ADDENDUM NO. 1

August 24, 2022

Modify Atrium Lighting & Sprinklers – Mann Library - REBID
Addendum No, 1
August 24, 2022
Page 2

100% CONSTRUCTION DOCUMENTS
SUCF 161039 - Modify Atrium
Lighting & Sprinklers-Mann Library
 237 Mann Drive, Ithaca, NY 14853

A101R1

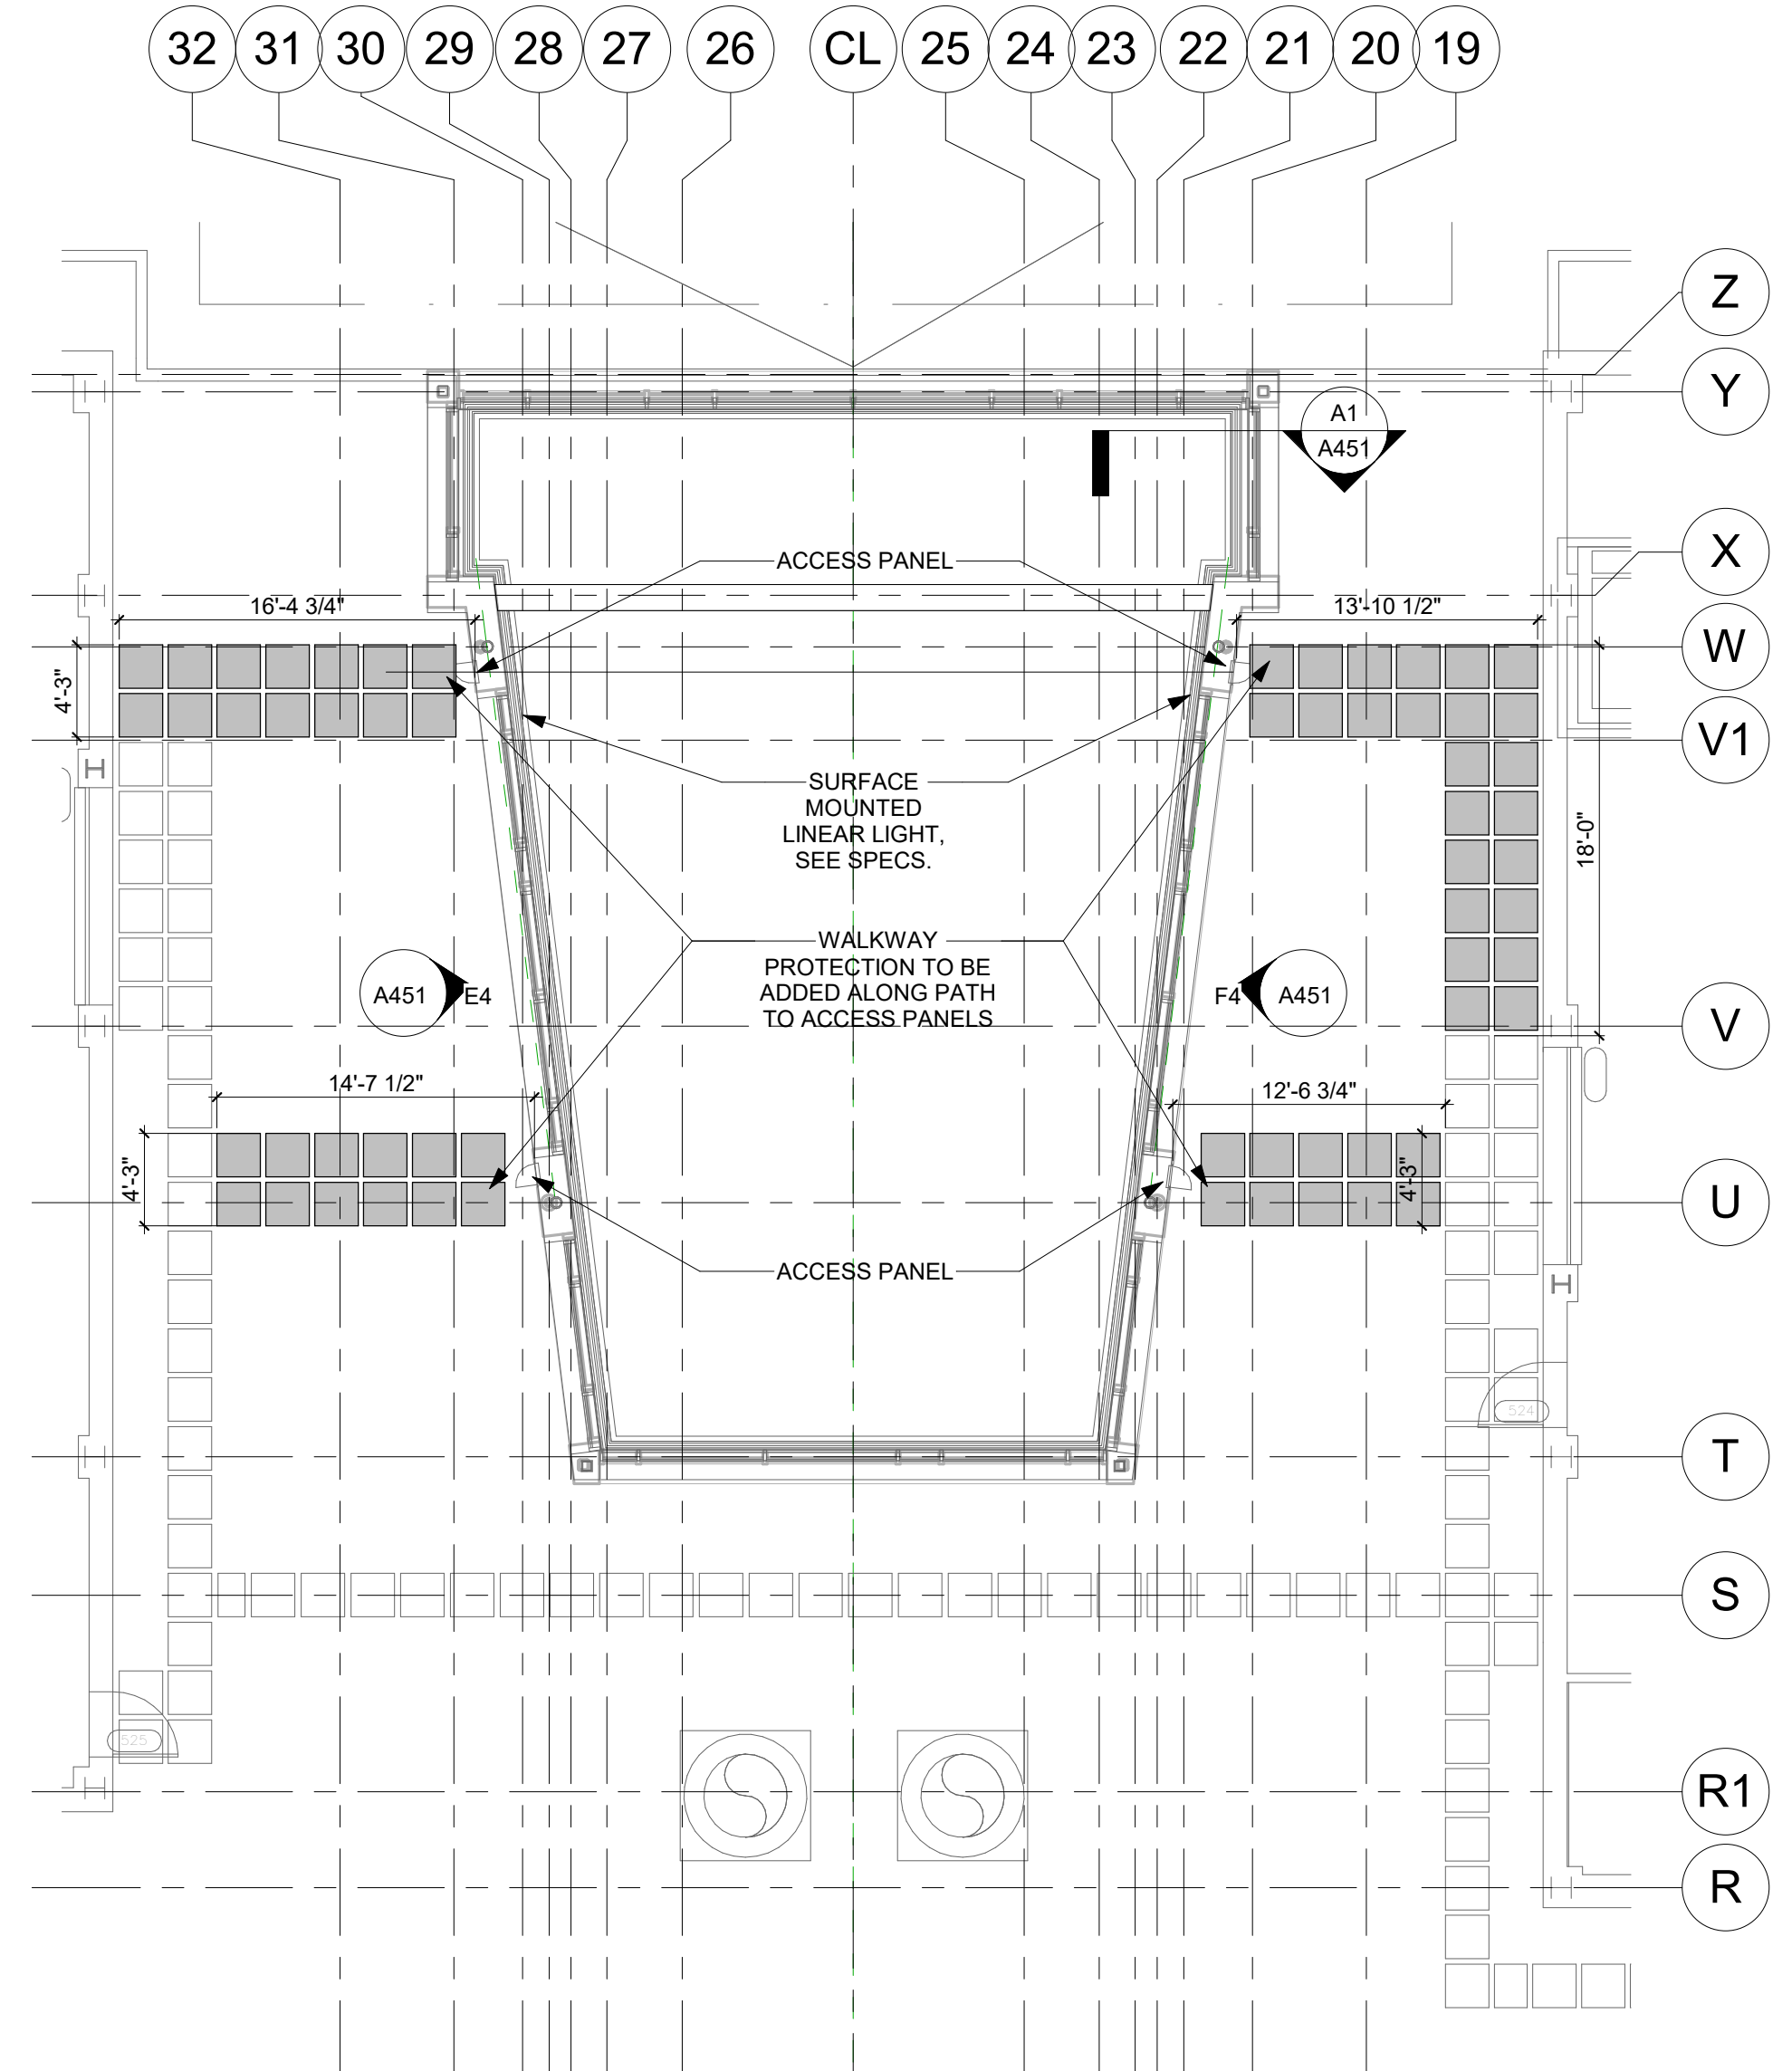
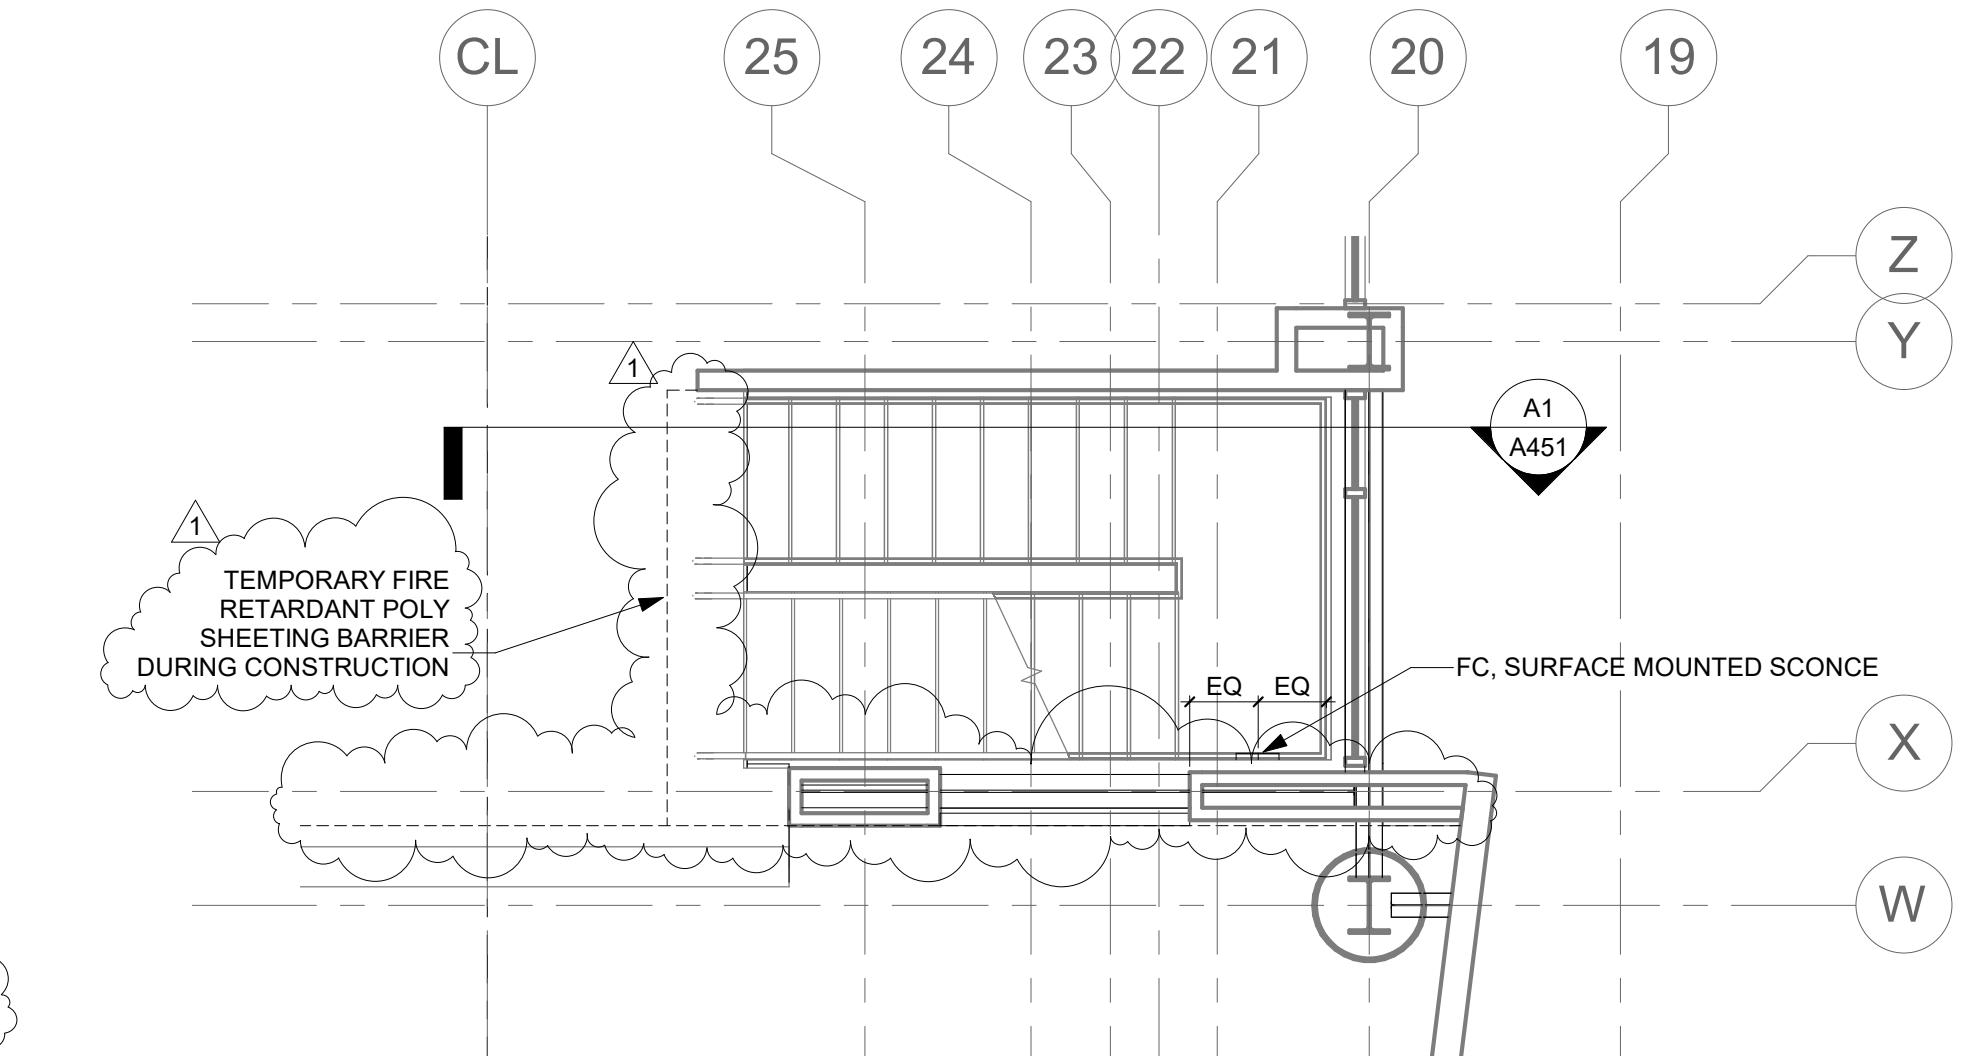
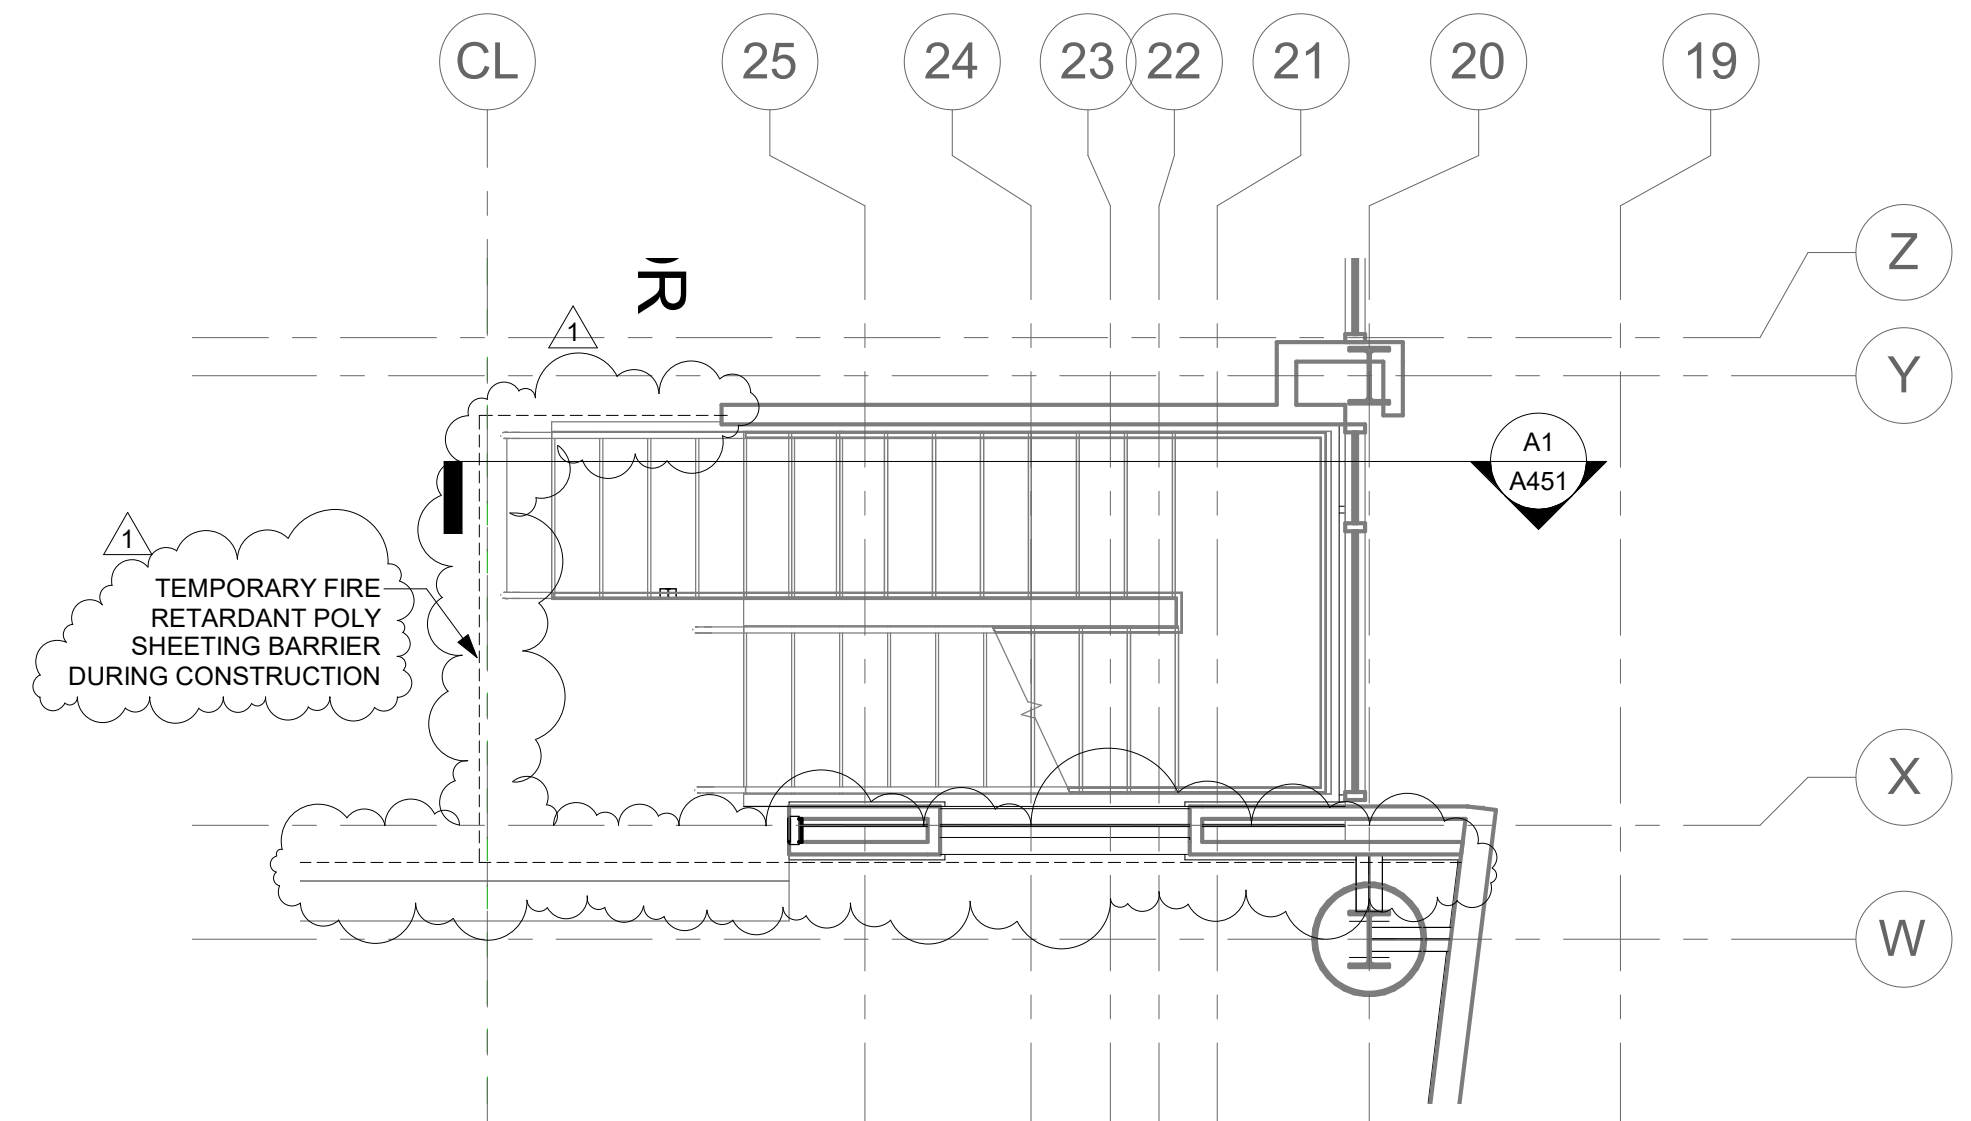
- NOTES:
1. INSTALL TEMPORARY FIRE RETARDANT POLY BARRIER DURING CONSTRUCTION TO LIMIT ACCESS AND PREVENT DUST FROM SPREADING. TAPE EDGES OF BARRIER AS REQUIRED TO PREVENT DUST MITIGATION.
 2. TEMPORARY FIRE RETARDANT POLY BARRIER AT ALL ENTRANCES TO STAIR 5 IS TO BE INSTALLED ONLY WHEN REQUIRED. STAIR 5 TO BE LEFT AVAILABLE FOR USE AT ALL OTHER TIMES.
 3. WINDOWS ARE TO BE CLEANED WHEN CONSTRUCTION IS SUBSTANTIALLY COMPLETE PRIOR TO REMOVAL OF SCAFFOLDING.
 4. MATS ON ROOF ARE TO MATCH PERFORMANCE OF EXISTING. QUANTITY AND LENGTH IS TO BE FIELD VERIFIED.
